**CITY OF WEST DES MOINES
PLAN AND ZONING COMMISSION COMMUNICATION**

Item: M&W Mini Storage, 2001 Grand Ave - Approval of Establishment of a Planned Unit Development (PUD) - MHC 80 (Des Moines, IA) LLC., d/b/a CubeSmart - ZC-004808-2020

Requested Action: Approval of New PUD Ordinance

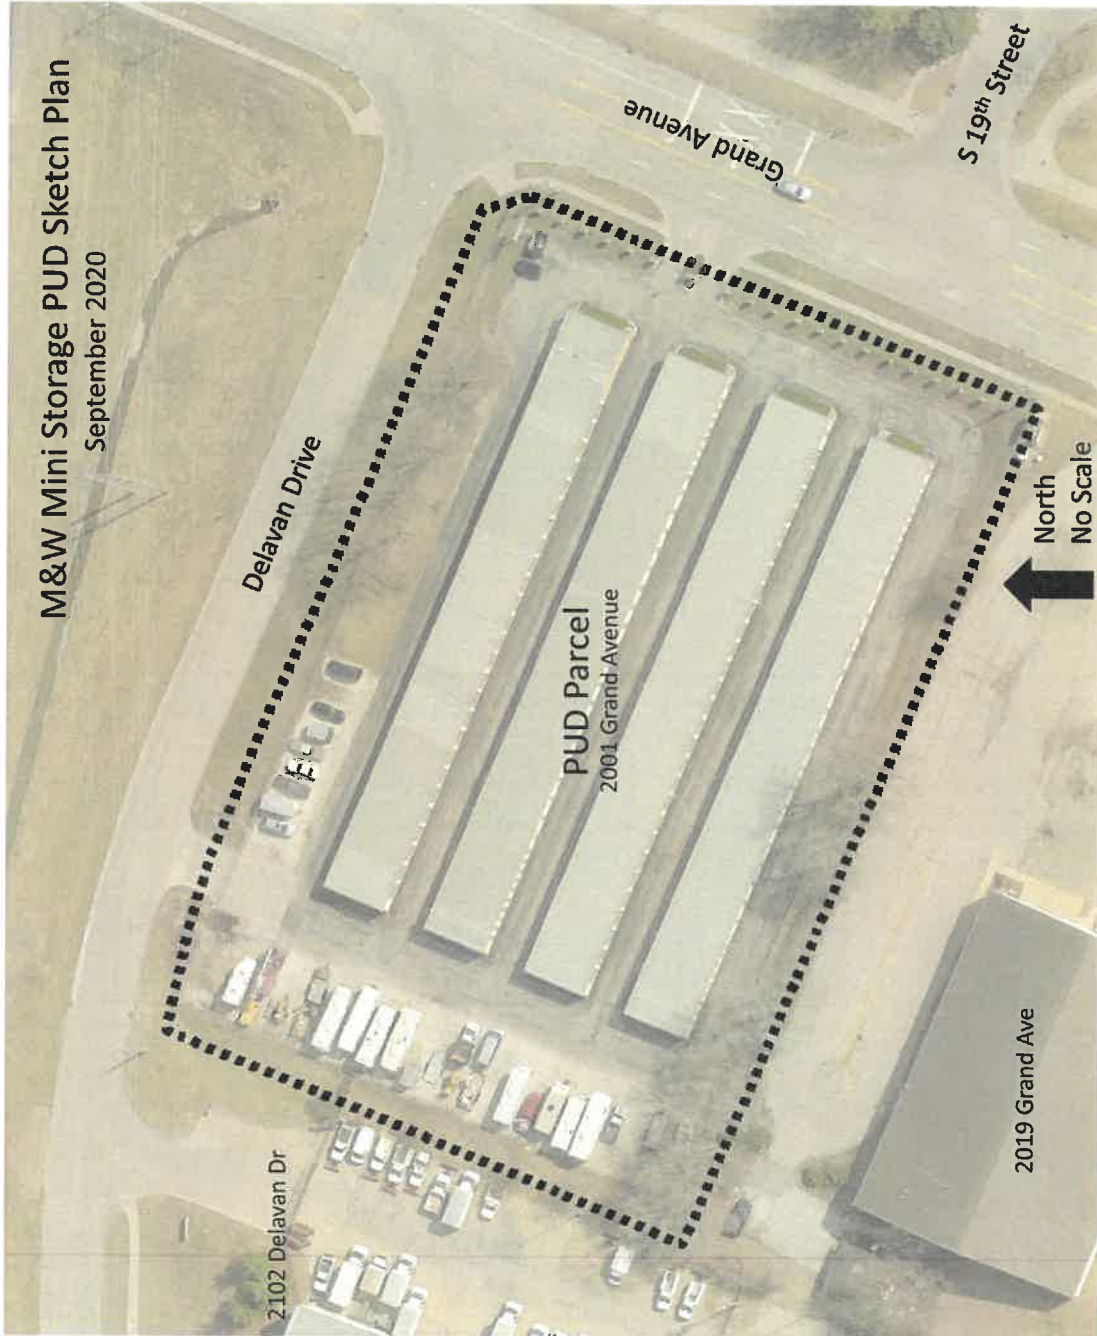
Issue: Parking Setbacks & Minimum # of Stalls Required

<i>1999 Plan</i>	10 ft. setback: provided minimum off-street parking for patron vehicles: vehicle storage parking encroaches into 10' setback at west end along Delavan Dr Required 3 stalls: provided 7 stalls
<i>Current Code</i>	10 ft. setback 0.5 spaces per 1,000 GFA -- requires 18 stalls within site
<i>Requested Action</i>	Allow current parking setback of west end of outdoor storage area Accept current number of parking stalls provided
<i>Necessary Action</i>	If front yard storage variance is approved, also need variance to minimum front yard storage parking lot setback for far west end Council defer minimum parking required until such time additional patron parking need is demonstrated – COA stating once demonstrated, require they repurpose portion of outdoor storage yard to patron parking and pave and stripe consistent with code Include specific COAs on site plan: * allowing only temporary vehicle parking within the drive aisles adjacent to the buildings for the purpose of loading and unloading items: once loading and unloading completed, vehicles should be moved to designated patron parking. * restricting patron parking areas from being utilized for outdoor storage

<i>Authority</i>	BOA consideration of variances; THEN P&Z and Council consideration of patron parking deferral
